Work Order ID 84099

Item Name: Crosstube Aft

DART AEROSPACE LTD		Work Order:	84099
Description: Crosstube High Aft (412)		Part Number:	D412-664-203
Inspection Dwg: D412-664-243 Rev: E		Page 1 of 1

DRAWING NO. D412-664-243	TITLE CROSSTUBE ASSEMBLY (412 HI AFT)	REV. E	DART AEROSPACE LTD ENGINEERING ORDER		D.E.O. NO. D412-664-243-E-1	SHEET NO. SHEET 1 OF 2	SCALE NTS
DRAWN	CHECKED	MFG. APPR.	APPROVED	DE APPR.			
DATE 11.03.31	DATE 11/03.31	DATE 11.03.31	DATE 11/03.31	DATE 11-03.31

CRUSHING OF D412-664-243

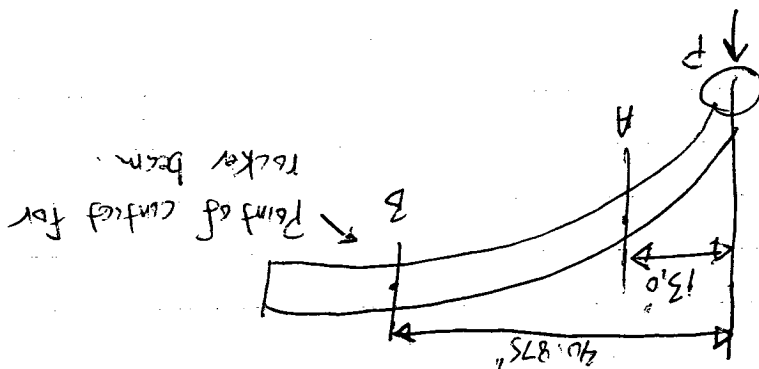
Acceptability of 8% CRUSHING AT END OF BEAD

Point A: $\omega_1 = 2.961$, $\omega_2 = 2.522$

Crushing = $(2.961 - 2.522) / (2.961 + 2.522) = 8\%$
 $I = 1.676 \text{ in}^4$ (from AutoCAD)

Point B: $\omega_1 = 3.307$, $I = 4.613 \text{ in}^4$

A: $F = M_c / I = P \times 13 \times 2.961 / 2 \times 1.676 = 11.484 \times P$
 B: $= P \times 40.875 \times 3.307 / 2 \times 4.613 = 14.651 \times P$

M.S. = $14.651 / 11.484 - 1 = 0.27$

∴ Tube will break at roller beam contact before area of 8% crushing; 8% crushing in area at end of tube
 bend is acceptable
